Re: Alternate Vesting Tentative Subdivision Map for the Bridle Gate Project

Figure 1
Alternate Vesting Tentative Subdivision Map

Review of the Bridle Gate project consistency with PD-36 Zone Development Standards and Brentwood General Plan Land Use Policies (APN 019-082-007)

Additional Intersection Circled in Red

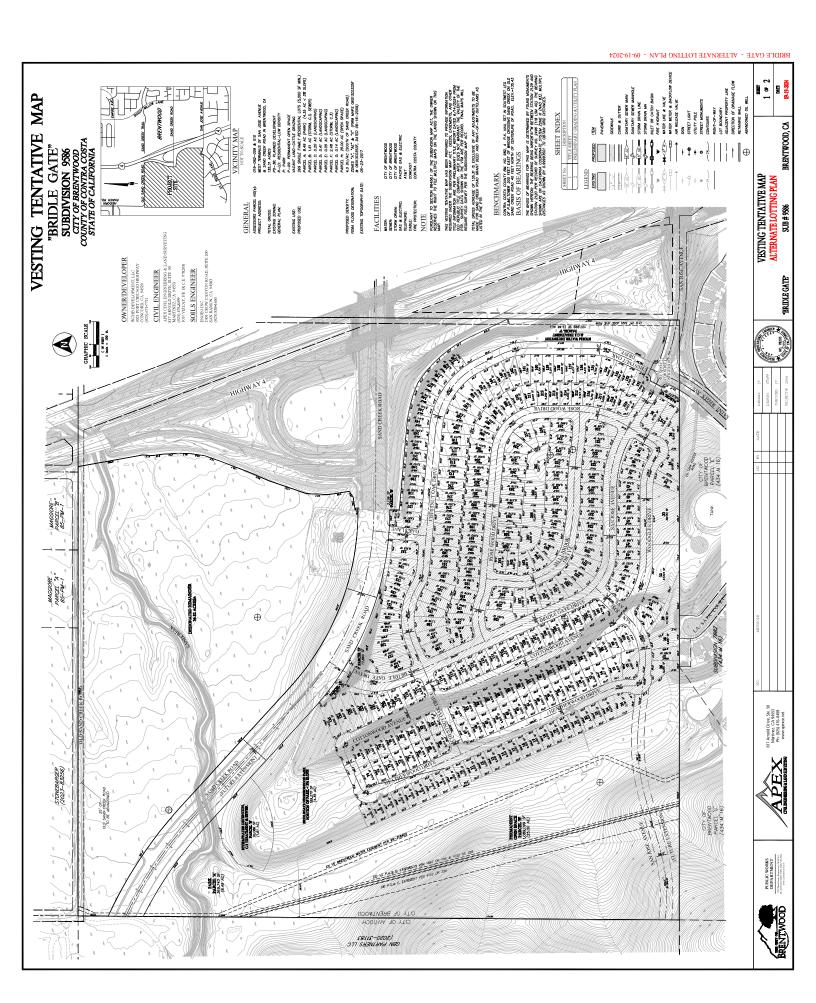
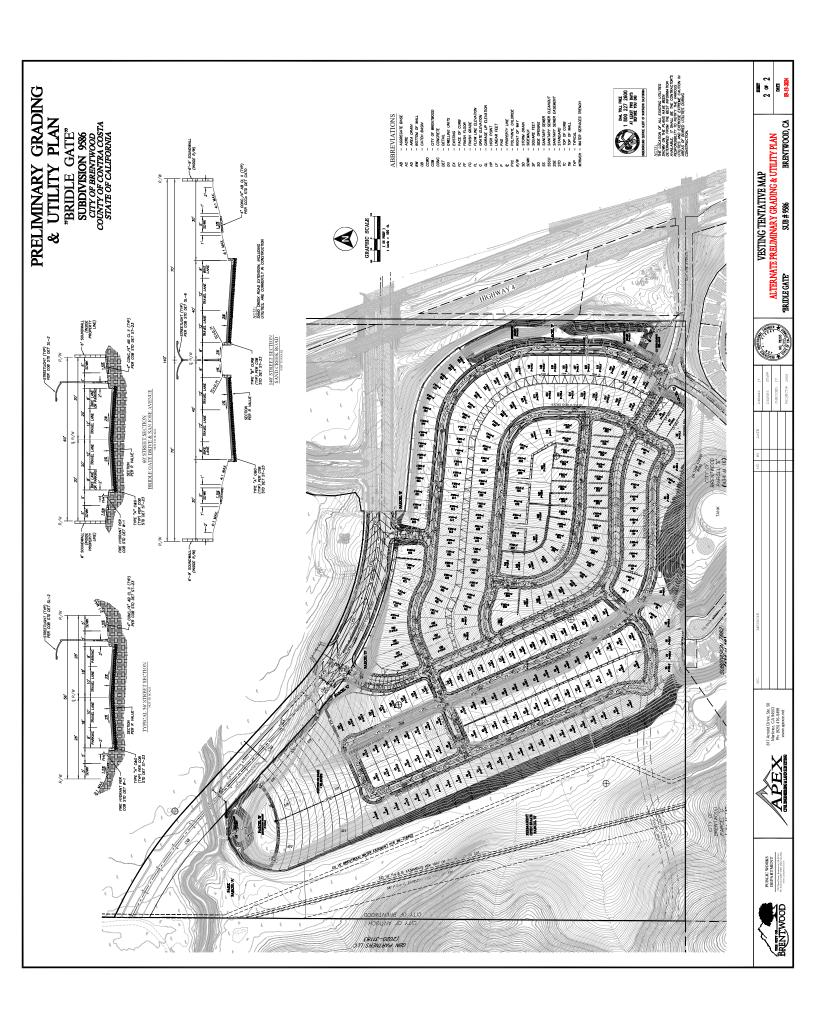
The most feasible and quantifiable strategy was determined to be an increase in intersection density, listed as Measure T-17. Under the previously considered site plan, the Project incorporated an additional intersection to achieve the intersection density needed to demonstrate mitigation. The most recent iteration of the Project site plan carries forward this intersection density. Taking credit for this previously incorporated measure would reduce the VMT per capita by approximately 10%, as documented in **Table 3**, resulting in a VMT per capita below the threshold of significance. Therefore, the proposed project is found to have a less-than-significant impact with mitigation.

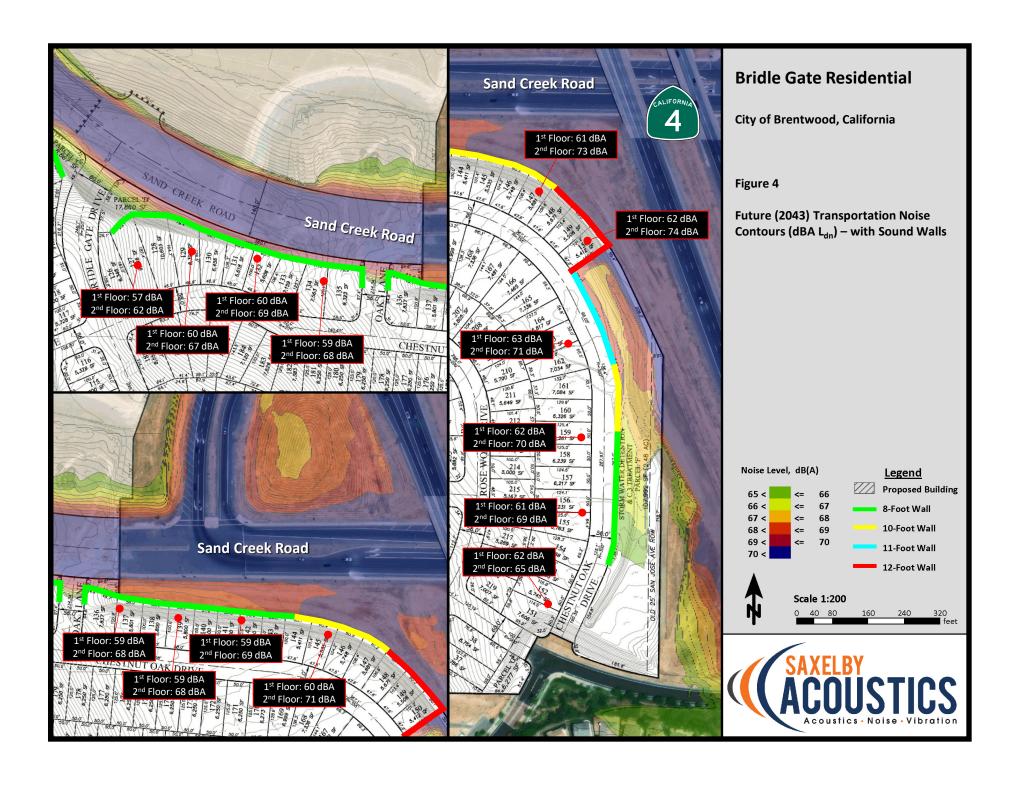
Saxelby's October 11, 2024 letter also included an updated noise contour and noise mitigation graphic (Figure 4), which shows the change in site plan indicating the location of the secondary access to Sand Creek Road.

BAC carefully reviewed Saxelby's updated Figure 4 and concluded there were no substantive changes to either predicted future traffic noise levels at the proposed residences or appreciable changes in required noise mitigation measures. The only difference noted by BAC staff was the break in the 8-foot tall San Creek Road noise barrier required to accommodate the secondary access to Sand Creek Road. BAC agrees with the wrapping of the noise barrier at that secondary access as indicated by Saxelby's updated Figure 4.

Because there were no other apparent differences in the project site plan which affected Saxelby's noise analysis, nor any changes in Saxelby's predicted noise levels or recommended mitigation measures, BAC's conclusions regarding the previous Saxelby noise study prepared for the project remain valid. Based on BAC's review of Saxelby's October 11, 2024 letter and attached updated Figure 4, it is BAC's professional opinion that the Saxelby Acoustics assessment has been properly prepared to address City of Brentwood requirements and BAC has no recommendations for modifications to the most recent Saxelby correspondence.
